RE: **#06ITB49977K-RS, Southwest Arts Center**

Addendum No.1

**SW Arts Phase II Performance Theatre**  
**ITB No. 06ITB 49977K-RS**  
**Addendum 1**  
**6/09/2006**

This Addendum forms a part of and modifies the bidding requirements and proposed Contract Documents for the subject Project, dated **May 8, 2006**. Receipt of this addendum shall be acknowledged on the Bid Form.

• SHEET TITLE  
• **WALL TYPE B2**

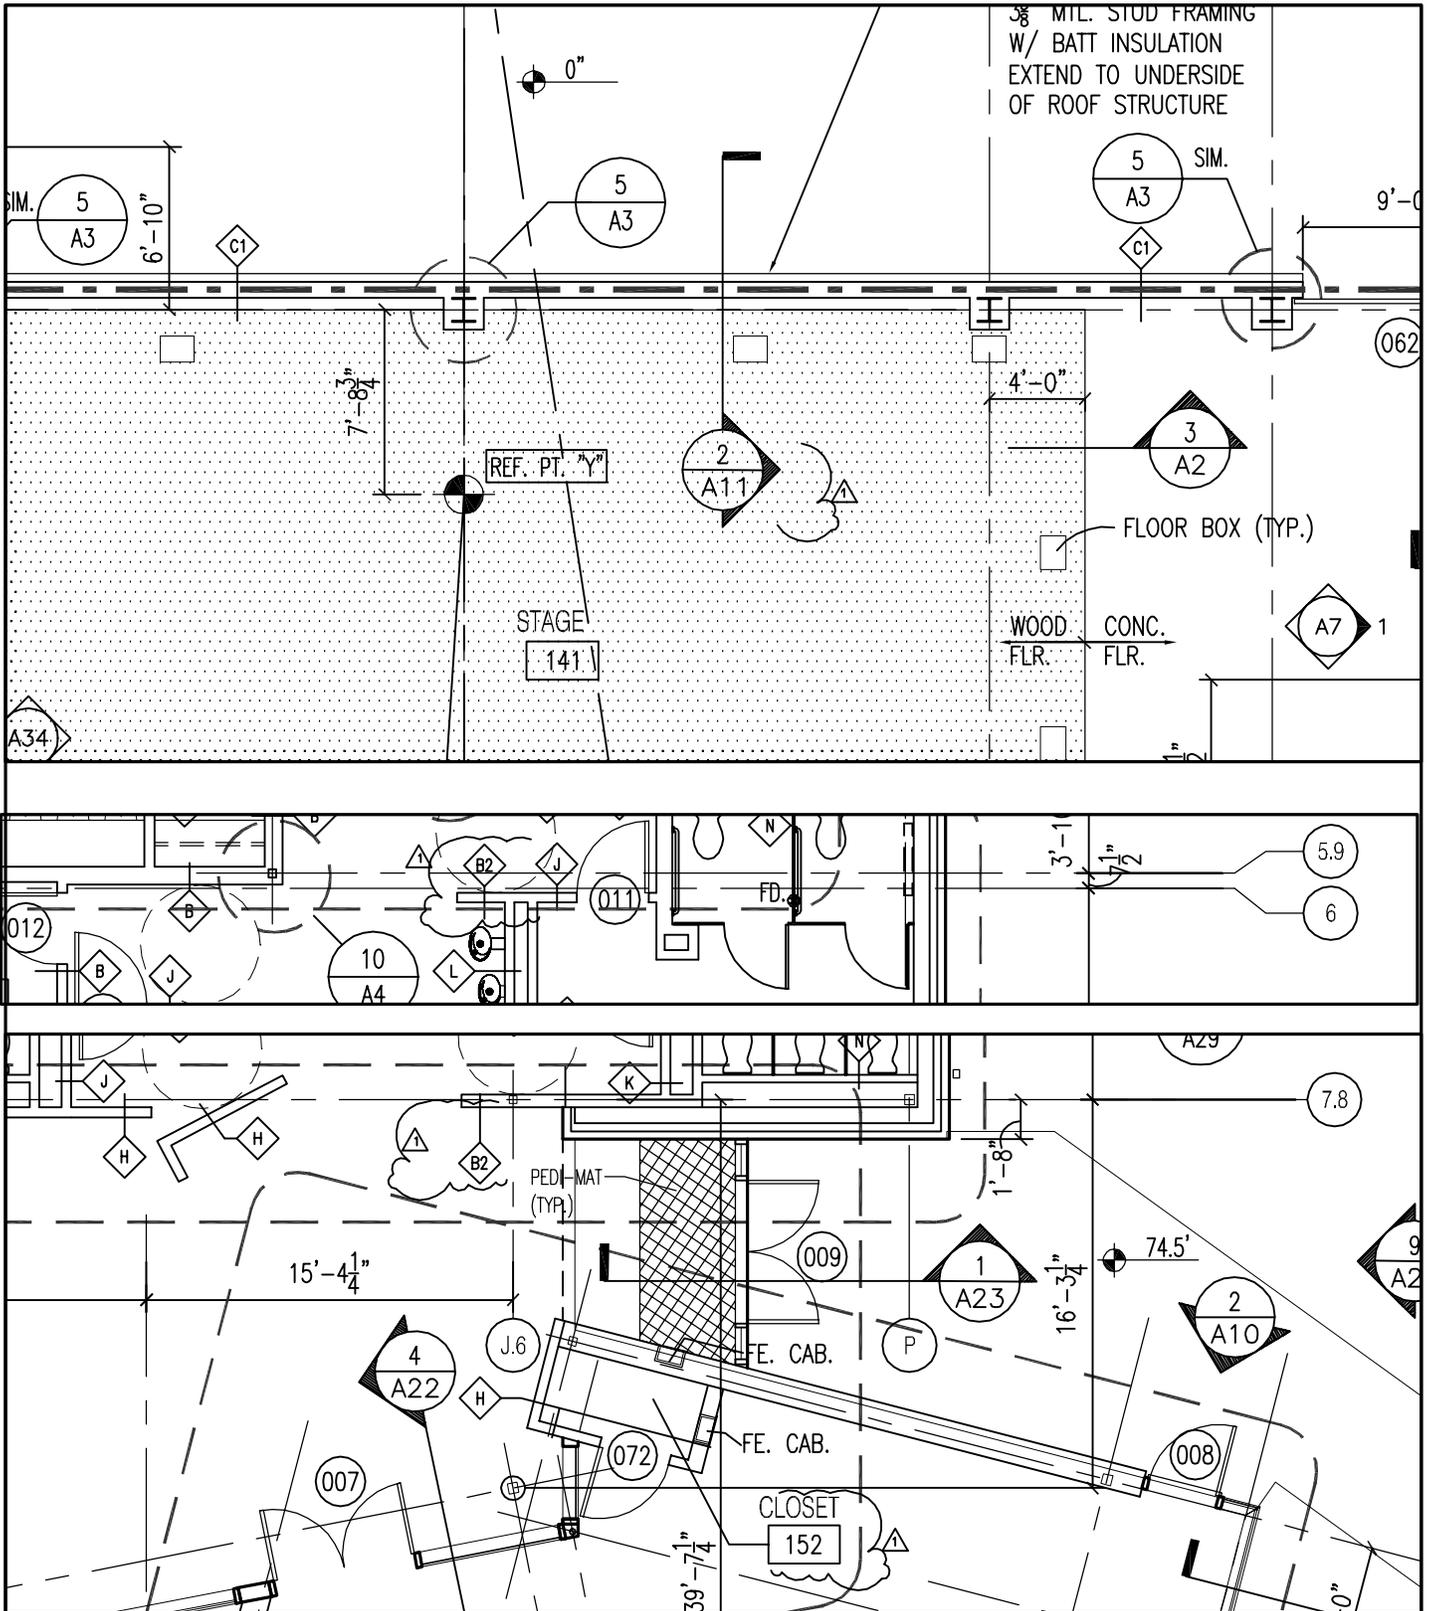
- Issue Revised Specification Section 00 150 Bidding Schedule
2. Issue SK-1:
  - adding wall type B2, for gypboard each side of CMU wall
3. Issue SK-2:
  - adding space name/number Closet 152 for closet at Gallery

PROJECT NAME	PROJECT NO.	DATE	SHEET NO.
FULTON COUNTY SW ARTS PHASE II THEATER	01145	5-30-06	SK2
SHEET TITLE	REF. SHT.	REVISION	SCALE
FLOOR PLAN	A2	Addendum 1	1/8" = 1'-0"

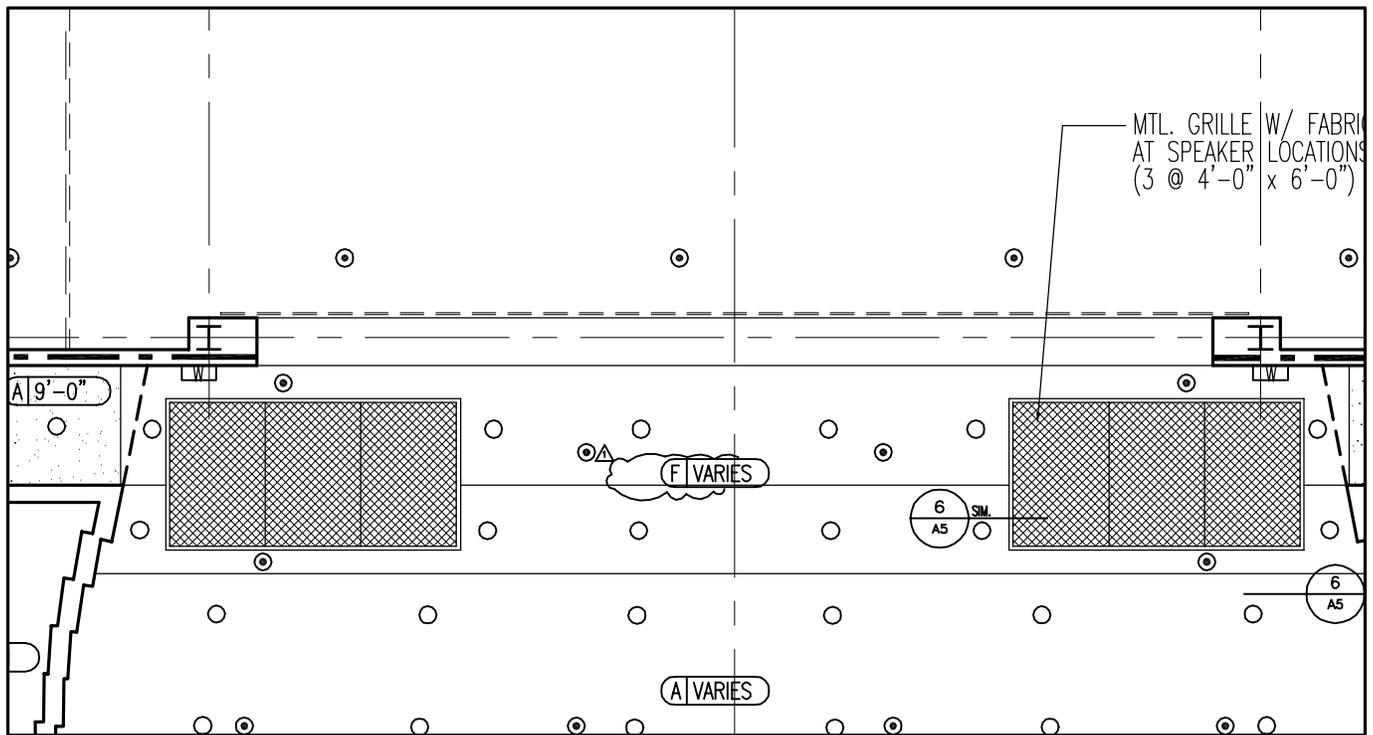
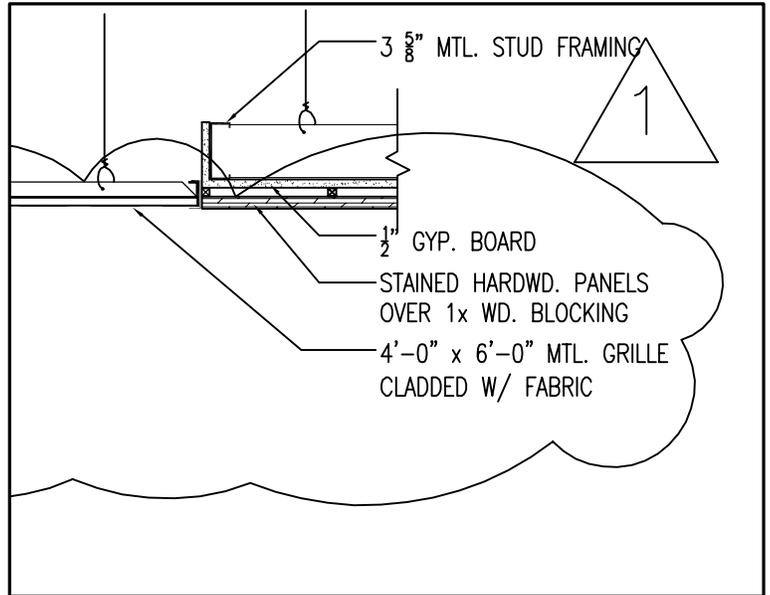
- revise wall type from Type E to Type B2 at entrances to Women 104
  - revise Section designation of 2/A11 at wall between stage and scene shop
  - delete tool crib

SHEET TITLE  
**REF. CEILING PLAN**

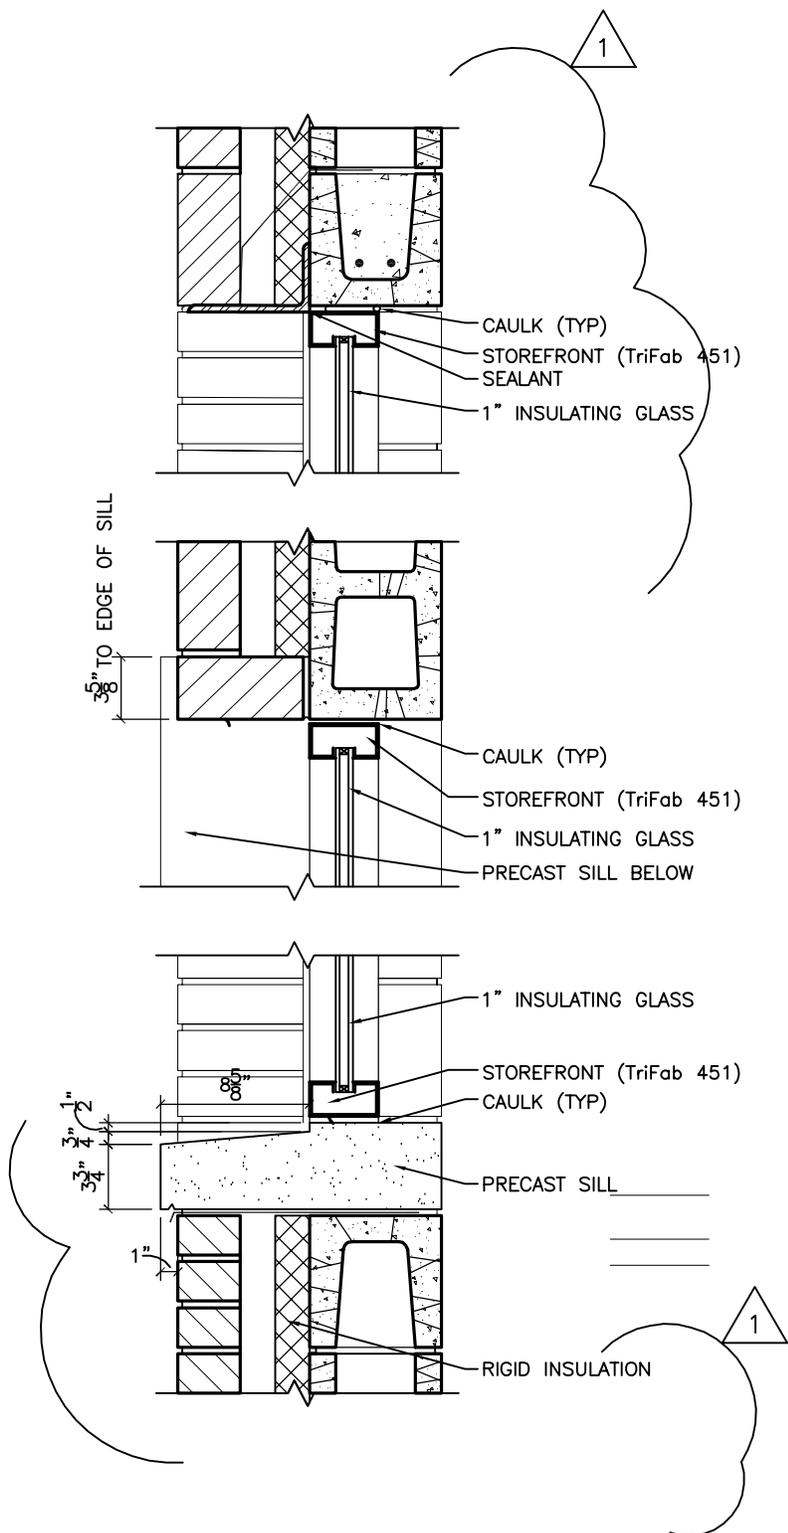
4. Issue SK-3:
  - Revise ceiling type at auditorium ceiling at proscenium opening to stage
  - Add ceiling type for wood panels
  - Add detail of ceiling at auditorium

• PROJECT NAME  
• **FULTON COUNTY**  
• **SW ARTS**  
• **PHASE II THEATER**  
• SHEET TITLE  
• **PRECAST SILL @**  
• **WINDOWS**

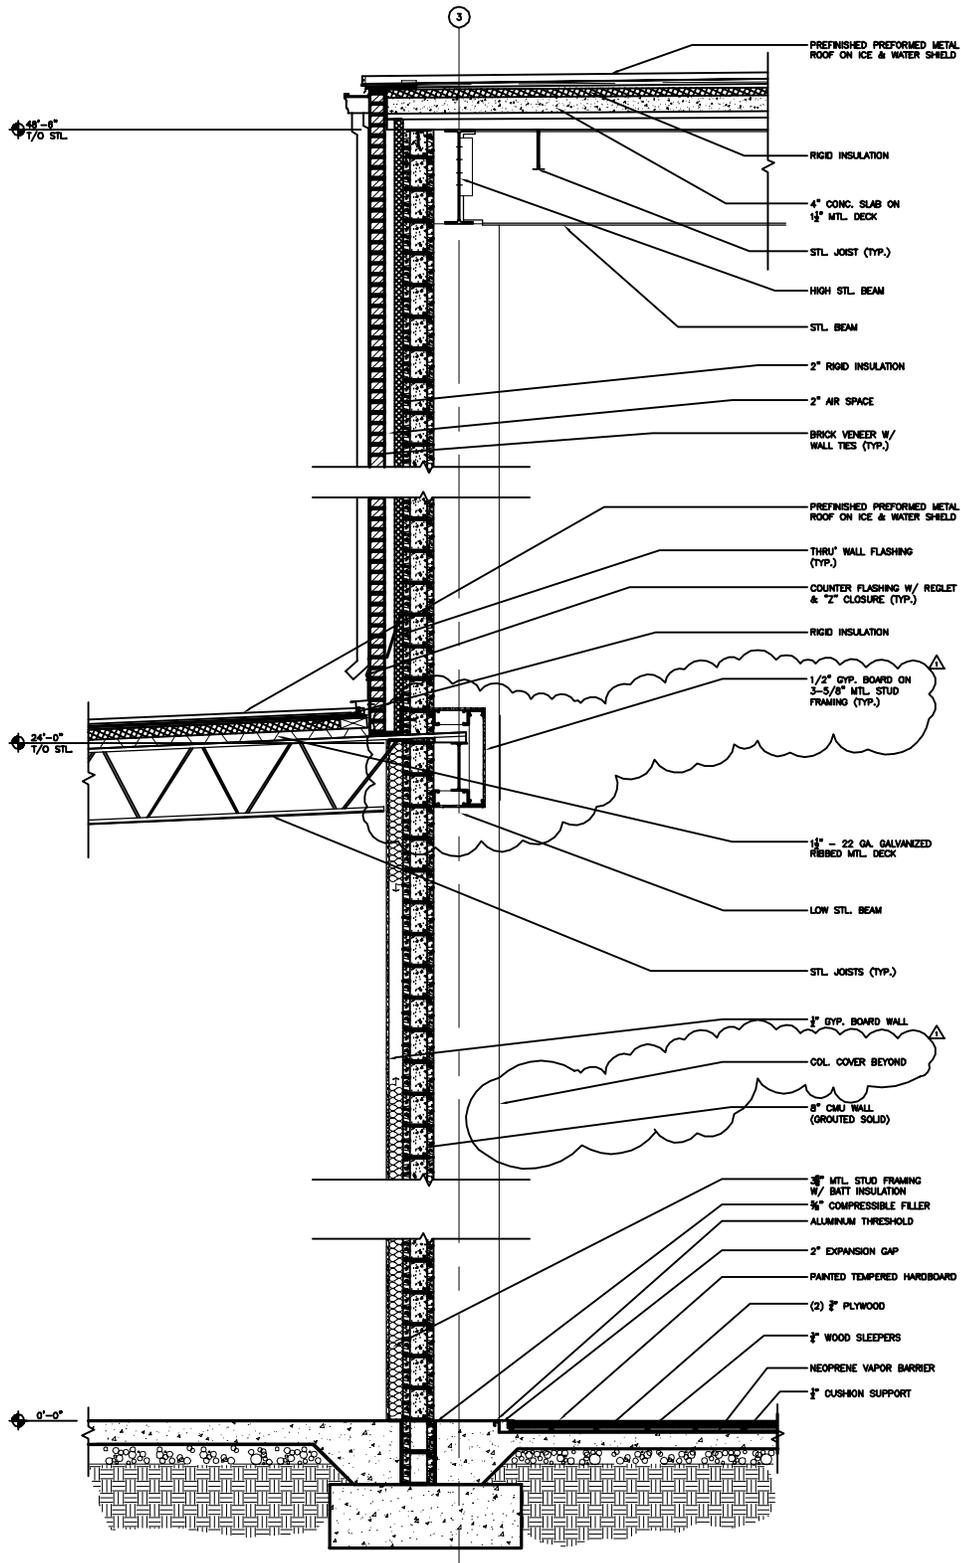
5. Issue SK-4:
  - Add details of precast window sills at rooms Office 148 and Green Room 139 on building elevation A9
6. Issue SK-5:
  - Revise wall section 2/A11 to indicate gypboard enclosure of beam and no steel column cover

. PROJECT NAME  
 . **FULTON COUNTY**  
 . **SW ARTS**  
 . **PHASE II THEATER**  
 . SHEET TITLE  
 . **WALL SECTION @ PIT**

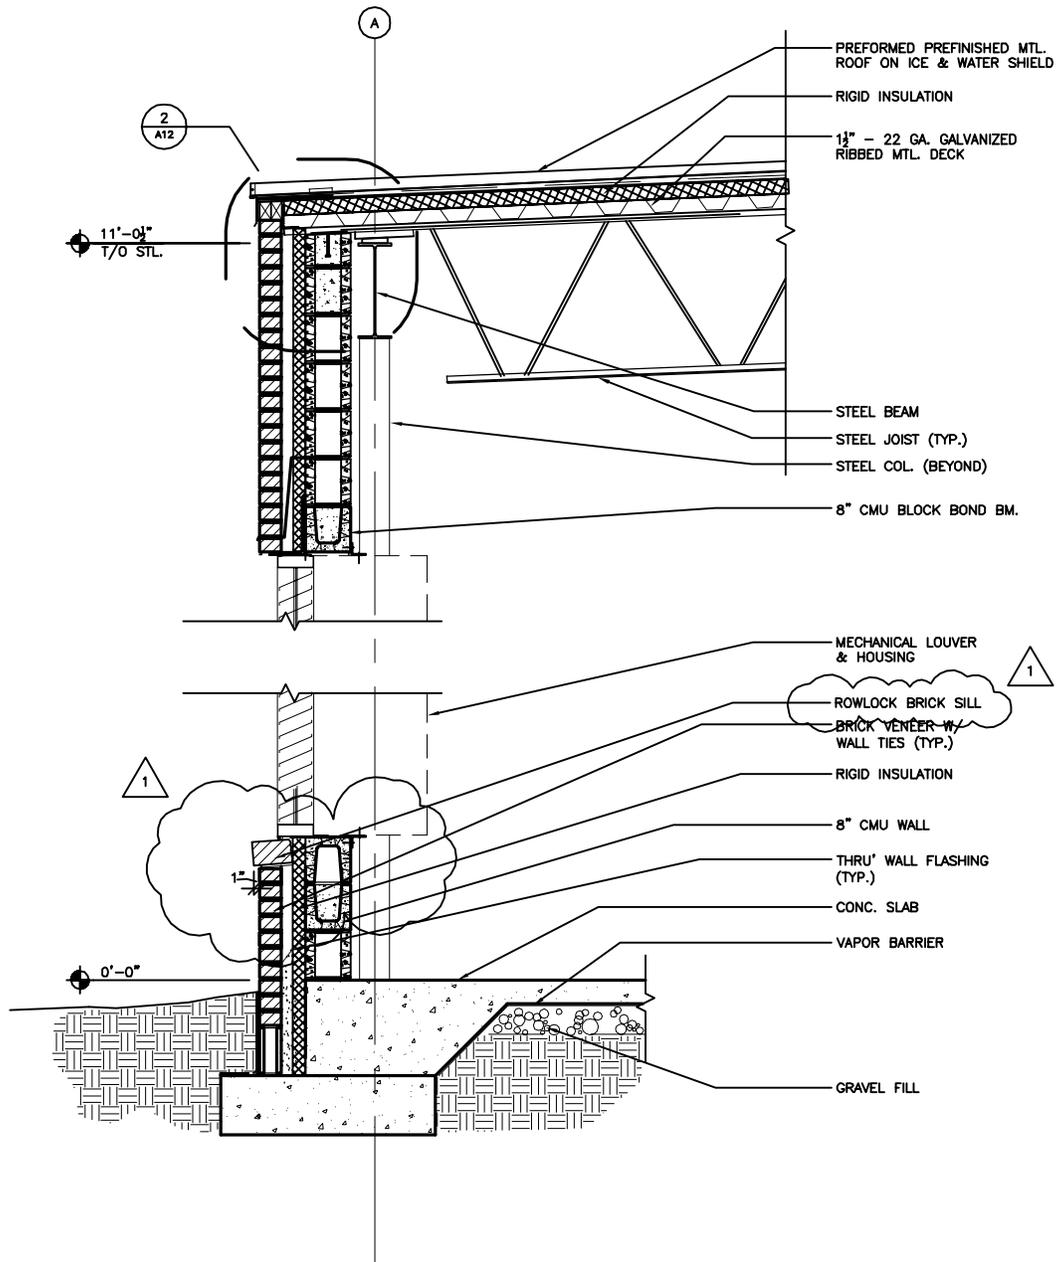
7. Issue SK-6:
  - Add location of waterproofing membrane below grade at stage pit
8. Issue SK-7:
  - Revise section 1/A15 to show brick rowlock sill detail at louvers

• PROJECT NAME  
• *FULTON COUNTY*  
• *SW ARTS*  
• *PHASE II THEATER*  
• SHEET TITLE  
• *LOBBY ELEVATION*

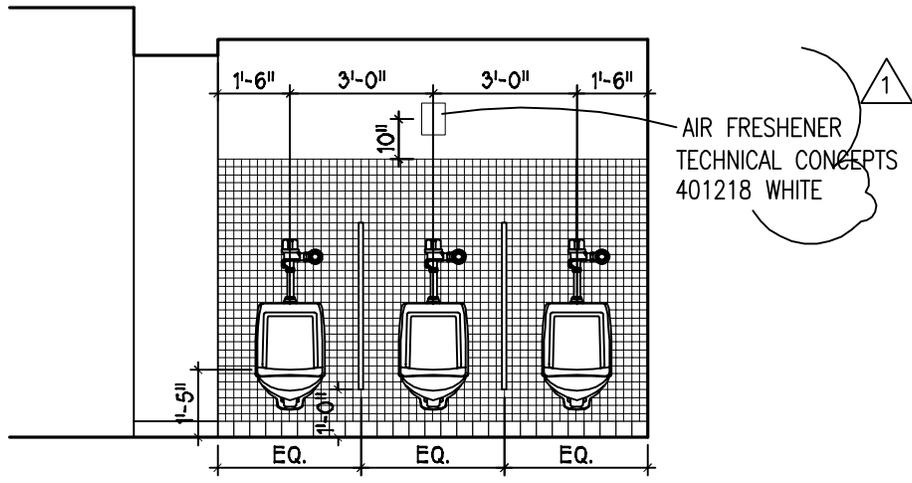
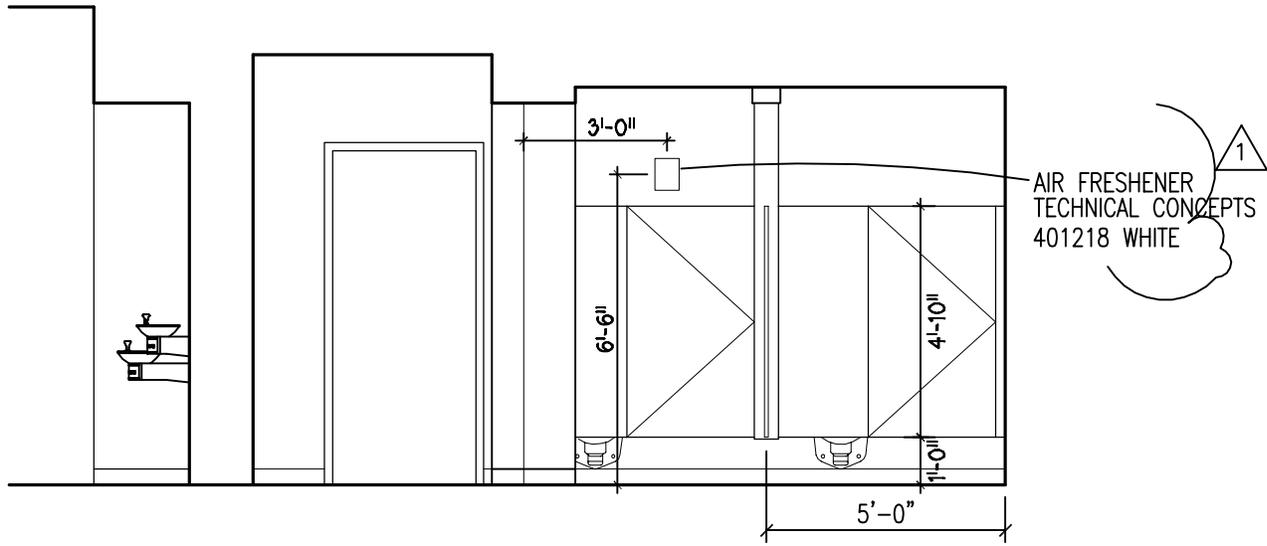
9. Issue SK-8:
  - Add dimension for column covers at lobby
10. Issue SK-9:
  - Add location and specification for automatic air freshener at men's and women's toilets

• SHEET TITLE  
• **DOOR SCHEDULE**

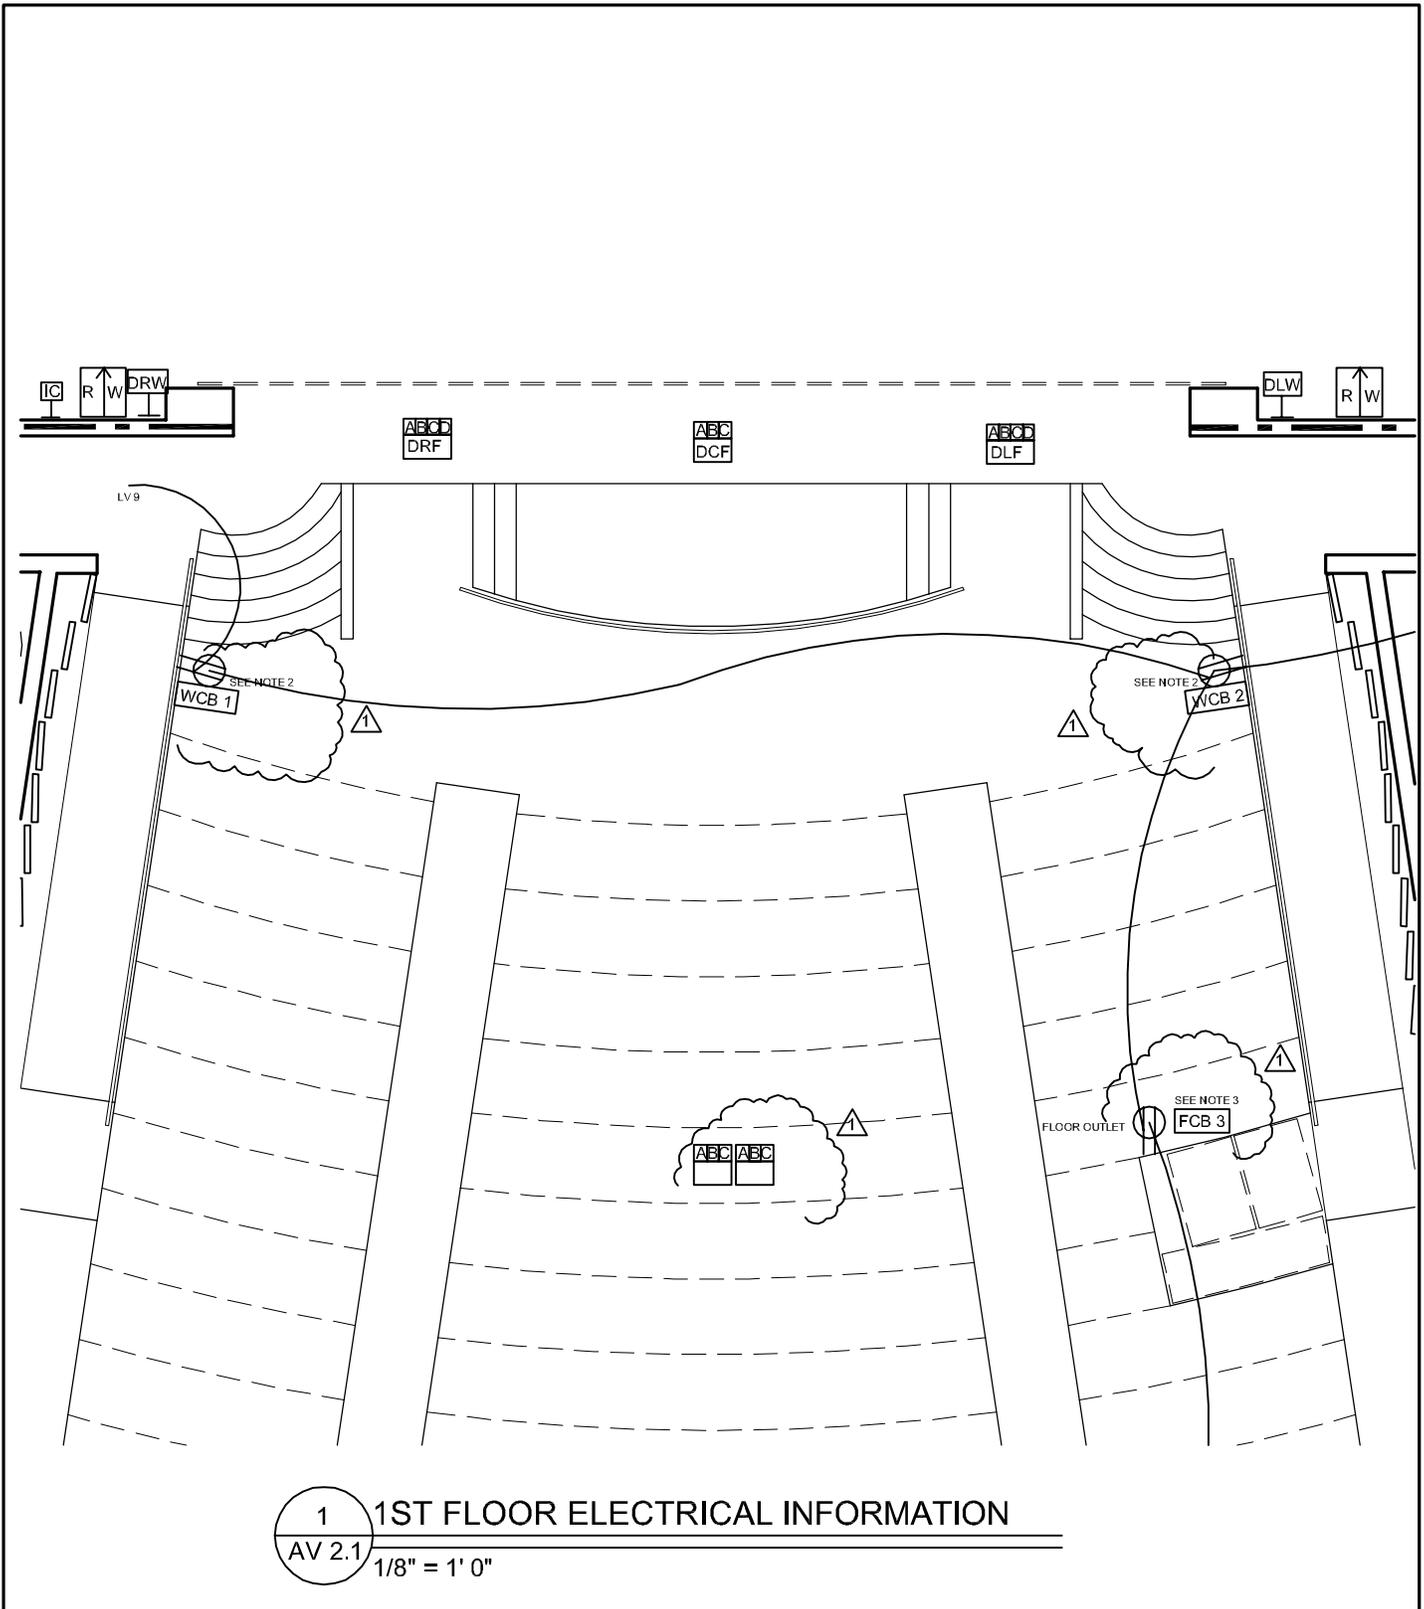
11. Issue SK-10:
  - Revise note for wire mesh at side wall lighting elements
12. Issue SK-11:
  - Delete question mark at door 067 of door schedule
